NORTH AMERICAN ELECTRIC
RELIABILITY CORPORATION

Industry Webinar

Modifications to PRC-025-1

August 16, 2017

Table 1. Relay Loadability Evaluation Criteria

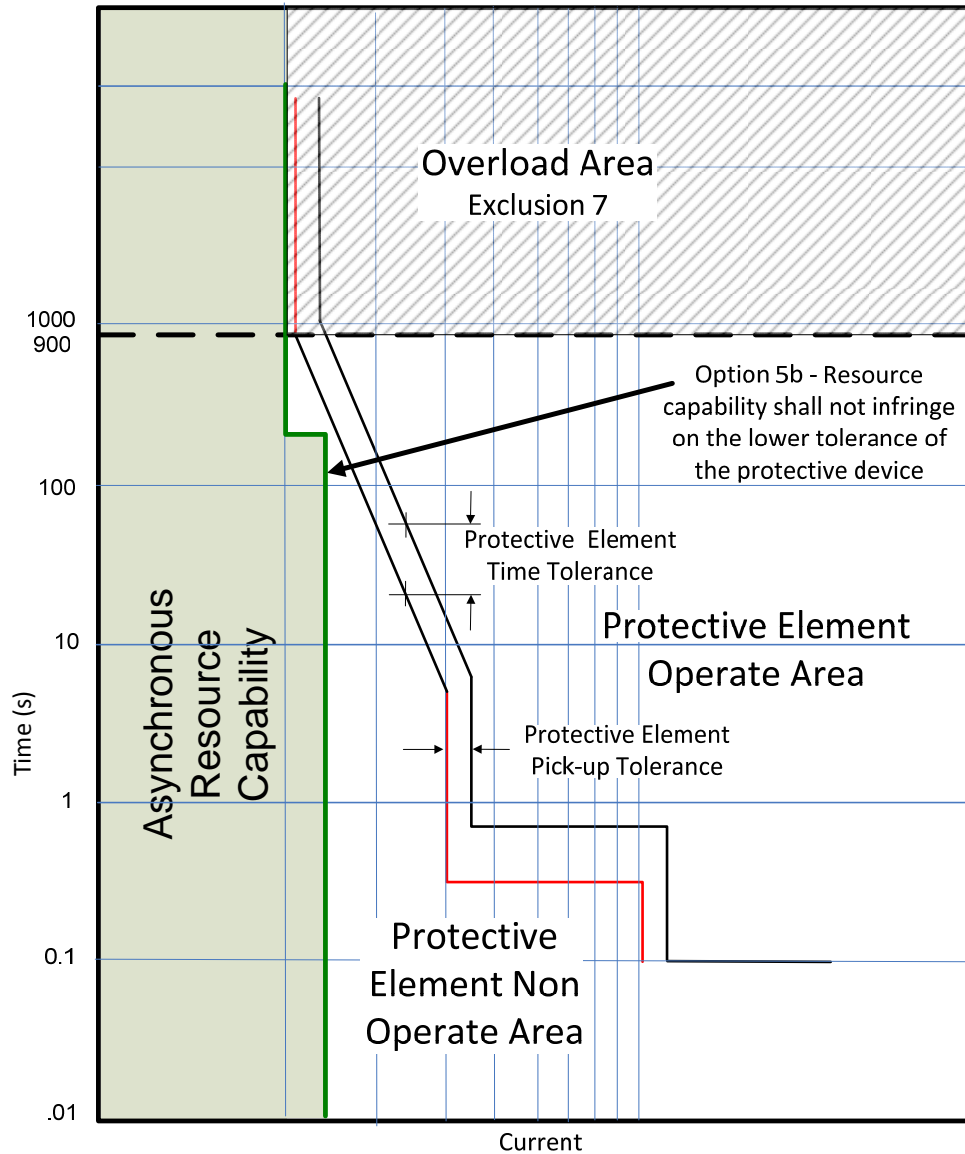
Application	Relay Type	Option	Bus Voltage ⁴	Pickup -Setting Criteria
Asynchronous generating unit(s) (including inverter-based installations), including or Elements utilized in the aggregation of dispersed power producing resources	Phase time overcurrent relay (e.g., 50, 51,) or (51V-R) – voltage-restrained)	5a	Generator bus voltage corresponding to 1.0 per unit of the high-side nominal voltage times the turns ratio of the generator step-up transformer	The overcurrent element shall be set greater than 130% of the calculated current derived from the maximum aggregate nameplate MVA output at rated power factor (including the Mvar output of any static or dynamic reactive power devices)
		OR		
		5b	<u>Generator bus voltage corresponding to 1.0 per unit of the high-side nominal voltage times the turns ratio of the generator step-up transformer</u>	<u>The protection element shall not infringe upon the resource capability (including the Mvar output of any static or dynamic reactive power devices) with worst case documented tolerances applied between equipment capability and the protection element (see Figure A).</u>

The protection element shall not infringe upon the resource capability (including the $Mvar$ output of any static or dynamic reactive power devices) with worst case documented tolerances applied between equipment capability and the protection element (see Figure A).
